ADDENDUM NO. 1

**RE: Salem Water Users Association PWA
2019 System Improvements
Contract – 1 Reed Trail Tank
2.0 M Gallon Elevated Composite Tank
Pulaski County, Arkansas**

FROM: GarNat Engineering, LLC
3825 Mt Carmel Road
Bryant, Arkansas 72022

CONTENTS:	
SITE & GRADING PLAN

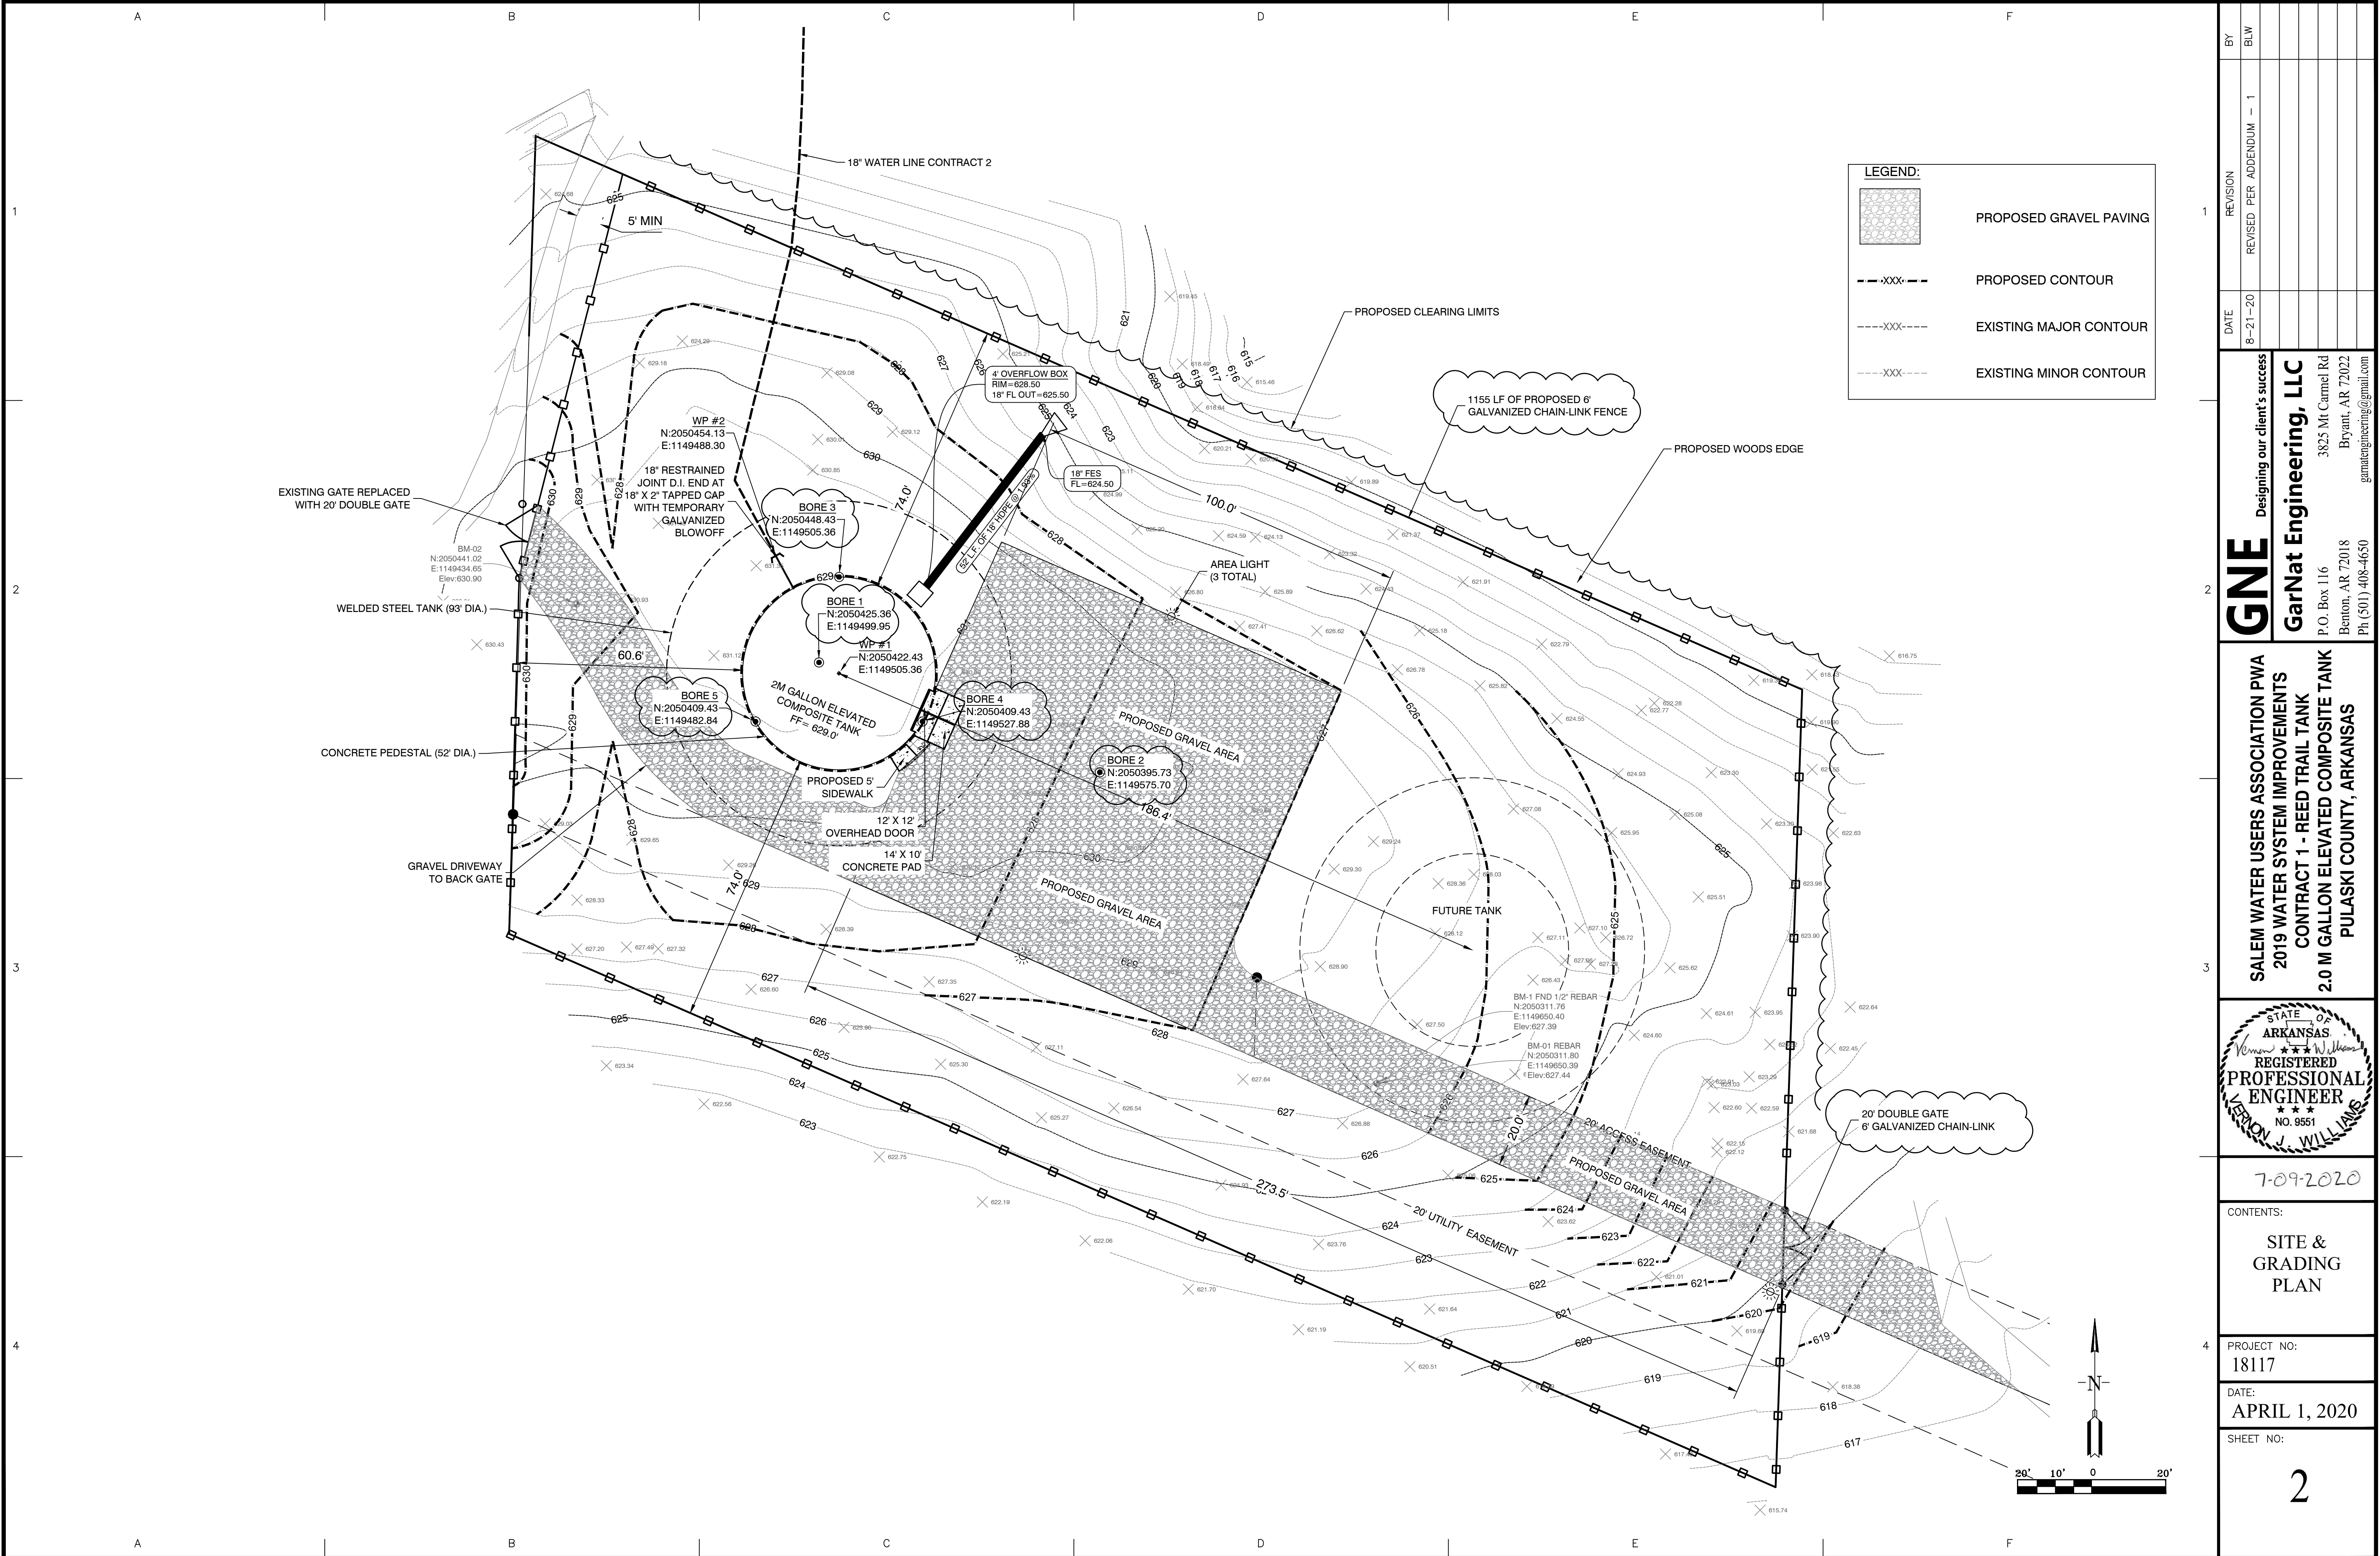
- A. Sheet 2 – Site & Grading Plan
1. Delete sheet and replace with enclosed document.

REVISED PER ADDENDUM - 1

TANK GROUND
FLOOR PLAN &
PIPING DETAILS

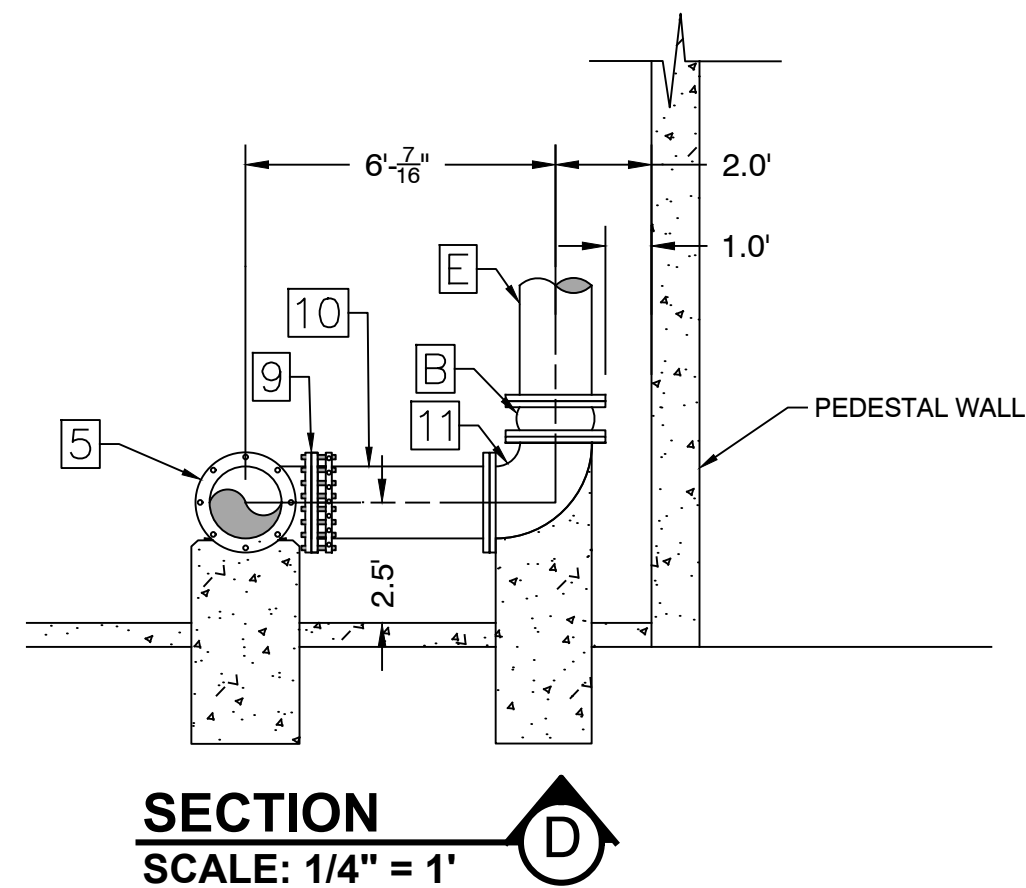
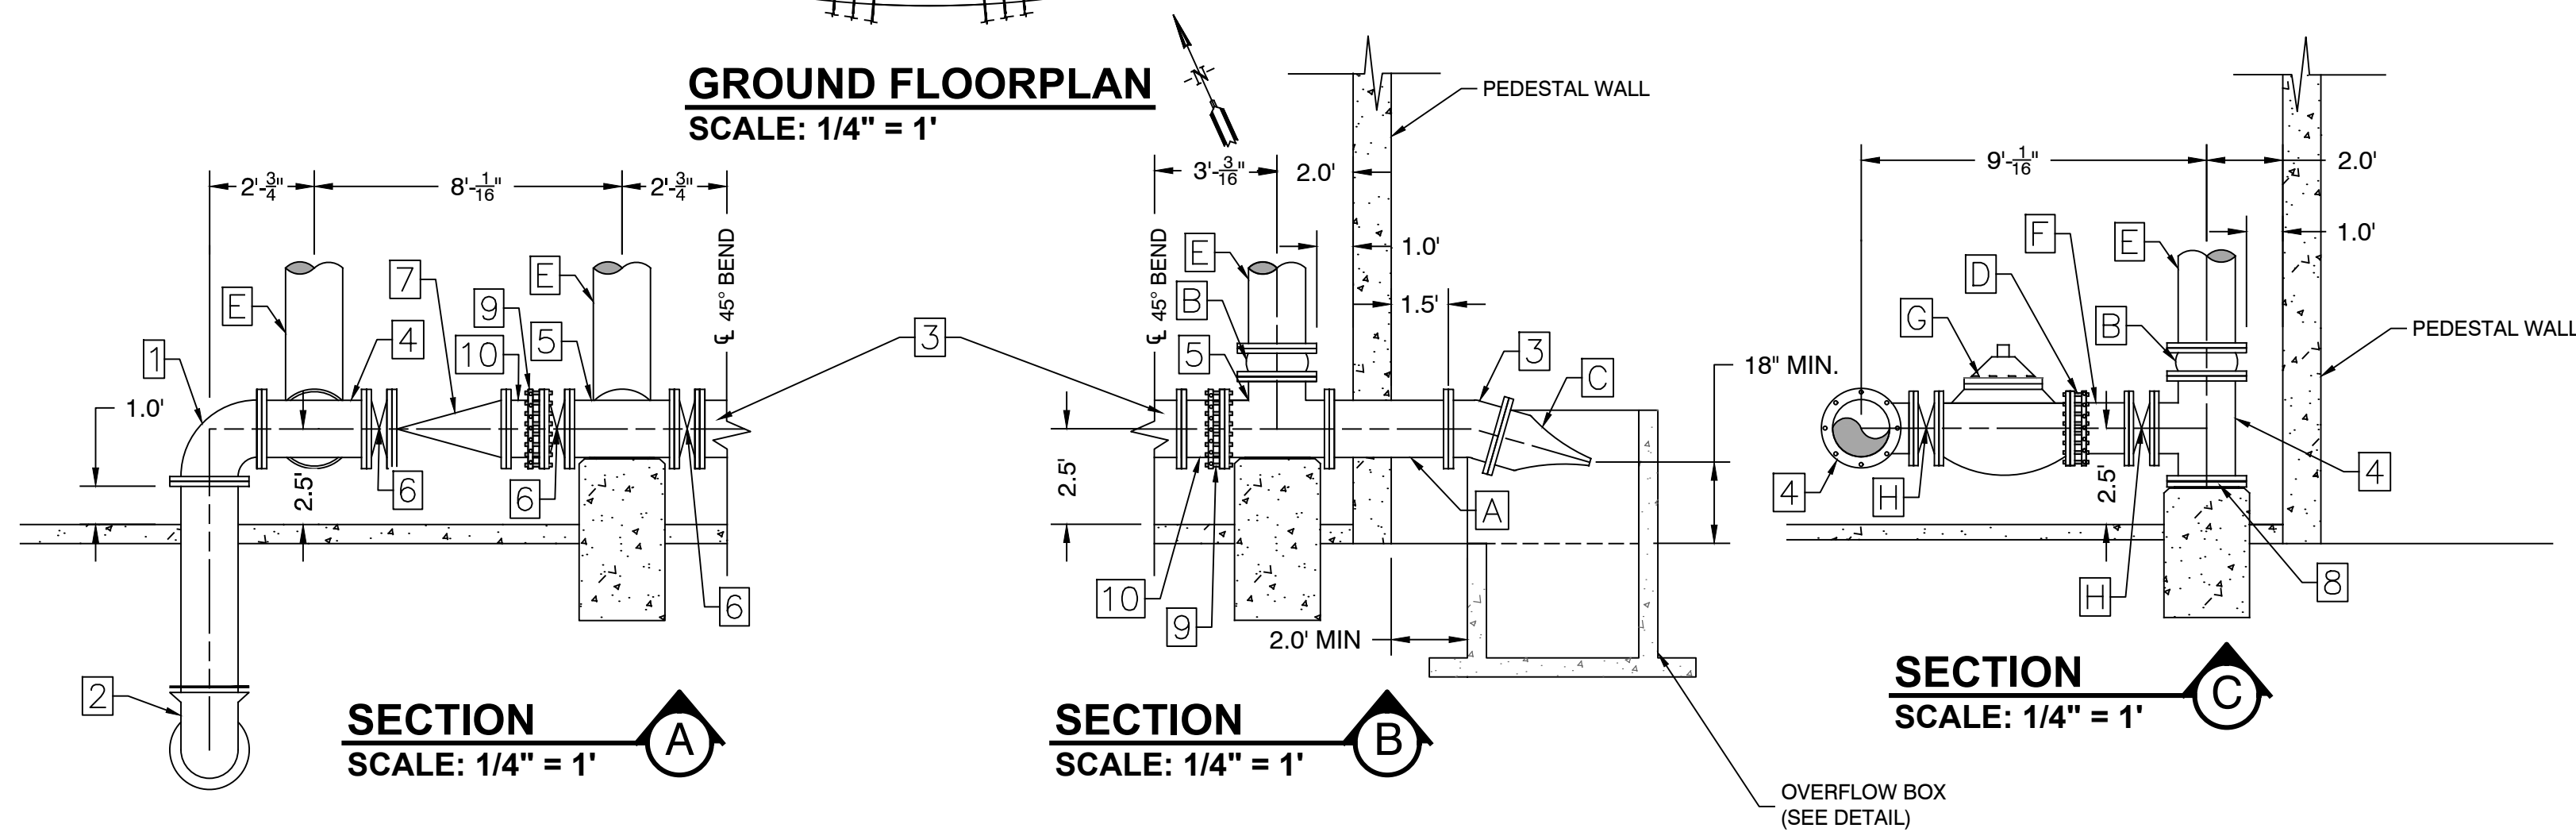
- B. Sheet 5 – Tank Ground Floor Plan & Piping Details
 - 1. Delete sheet and replace with enclosed document.

- F. Section 02640 – Valves and Hydrants
 - 1. Delete paragraph 2.07. Check Valve specified on Sheet 5 of Plans.
- G. Section 13100 – Composite Elevated Water Storage Tank
